**STATE OF MARYLAND  
CRITICAL AREA COMMISSION  
CHESAPEAKE AND ATLANTIC COASTAL BAYS**

Re: Bay Meadow Industrial Park  
C 08-0025, G 02013383

Thank you for forwarding the revised site plan for review and comment. The applicant proposes to construct a 65,000 square foot commercial building and parking lots on an undeveloped 6.54 acre parcel in the Critical Area. The property is designated as an Intensely Developed Area (IDA). The applicant has addressed most of this office's comments from my July 11, 2008 letter. I have provided my remaining comments below:

### SITE DEVELOPMENT PLAN

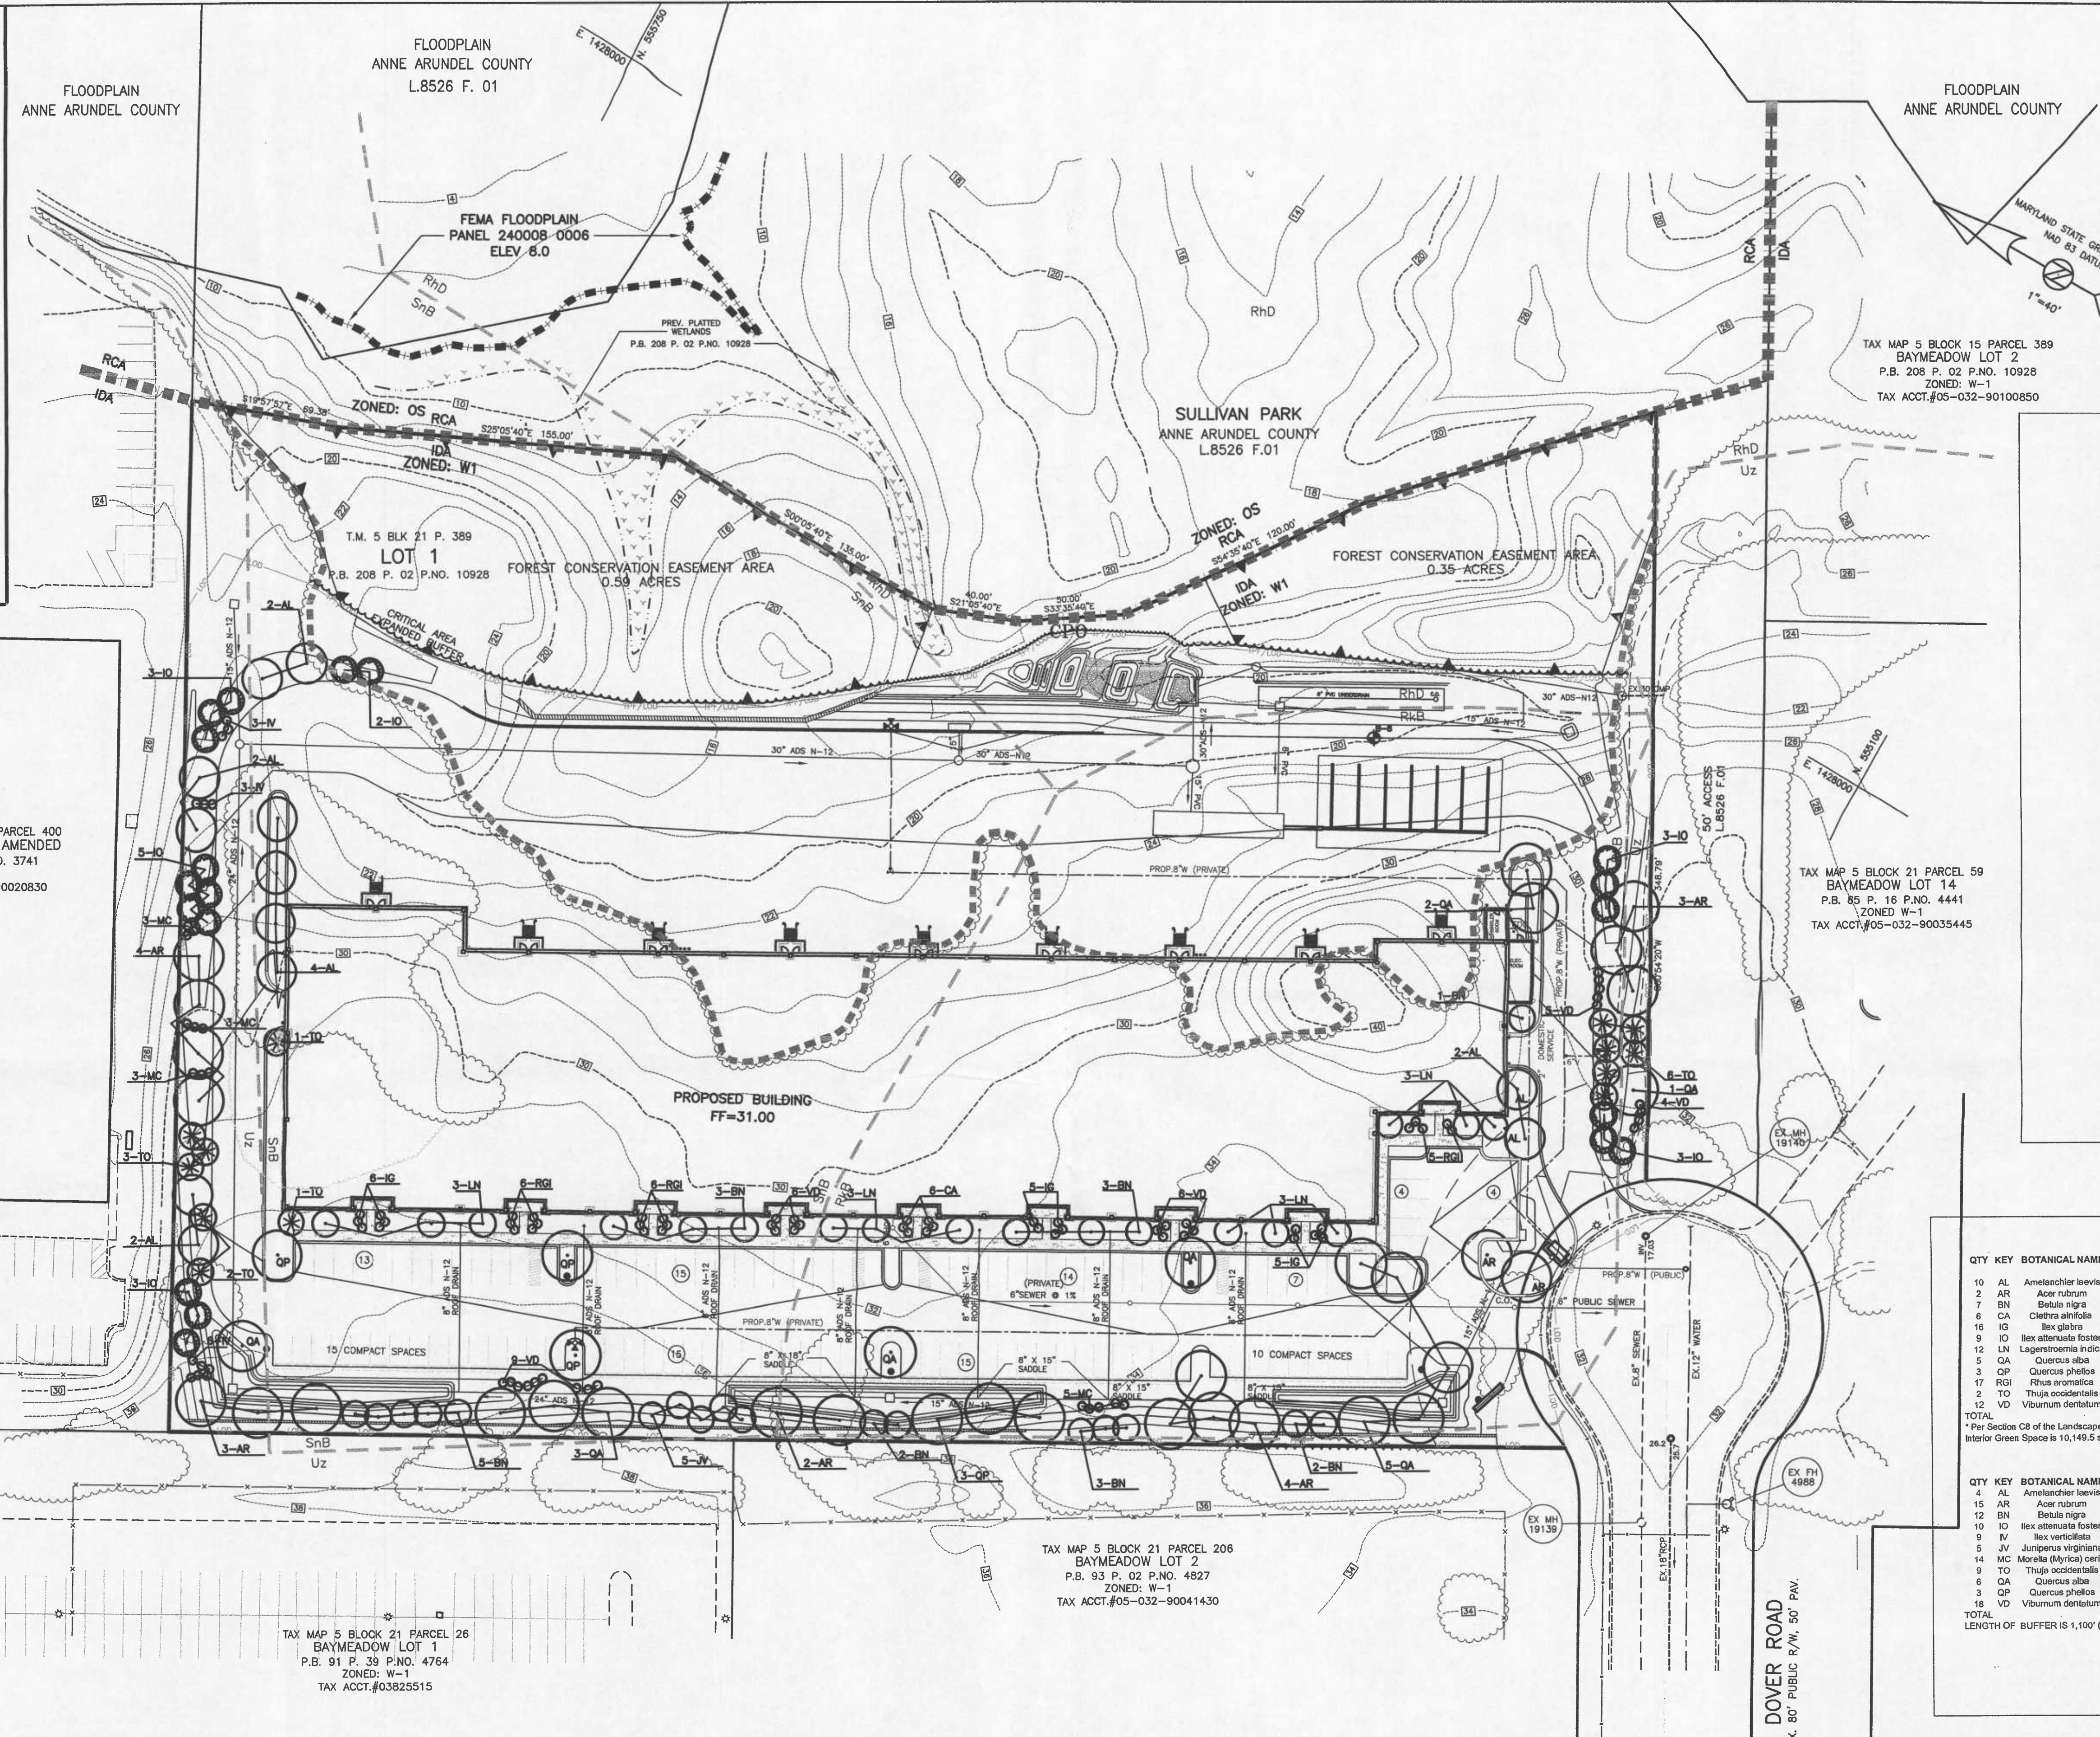
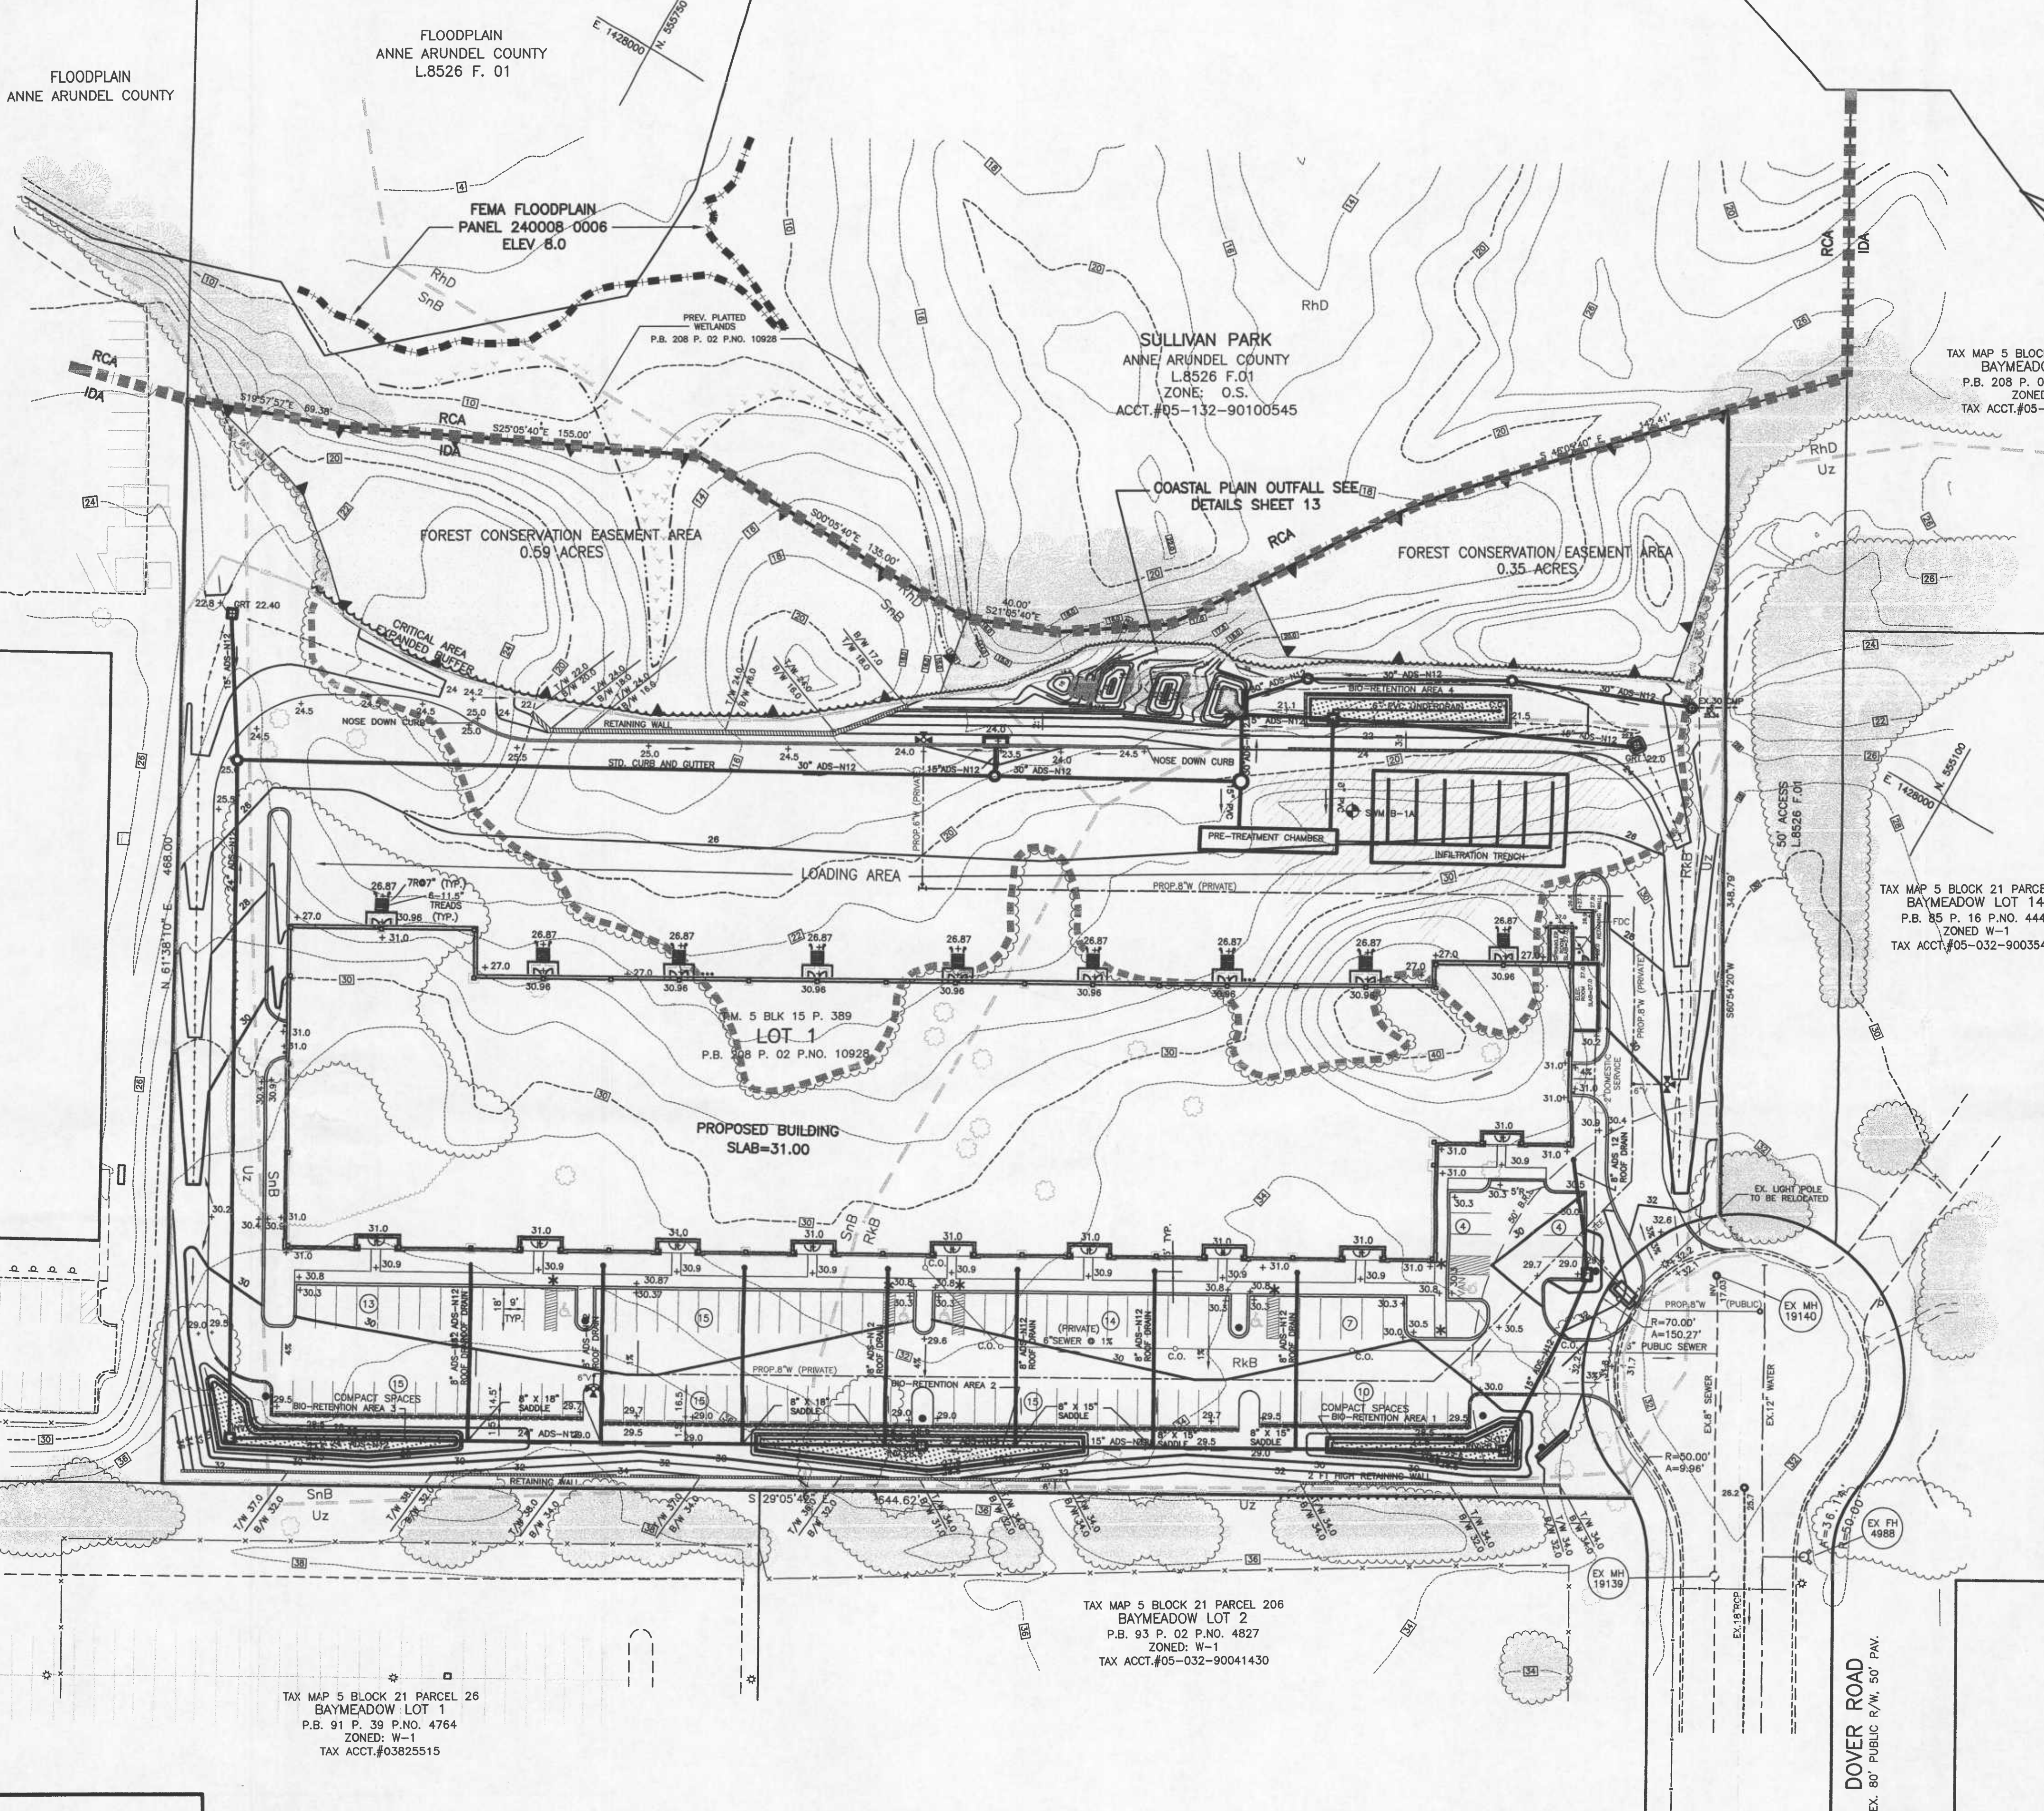
1. It is unclear how the 0.37 acres of impervious surface that were deducted using the grass channel credit were calculated. I calculate from the plans that there are 2.35 acres of parking lot, and subtracting the 1.89 acres of remaining parking lot shown on the 10% calculation leaves 0.46 acres instead of 0.37 acres. Please have the applicant clarify how the 0.37 acre impervious surface deduction was calculated.

2. Please have the applicant provide the acreages of the onsite drainage areas that are directed to each of the BMPs. I was able to locate a chart with acreages for the proposed grass channels but not for any of the BMPS.

3. In order to count portions of drainage areas that first flow through one BMP toward the drainage area served of the infiltration trench, the applicant must use the "BMPs in a series" formula found in the frequently asked questions section of the Critical Area 10% Rule Guidance Manual, p. 7-9, #27.
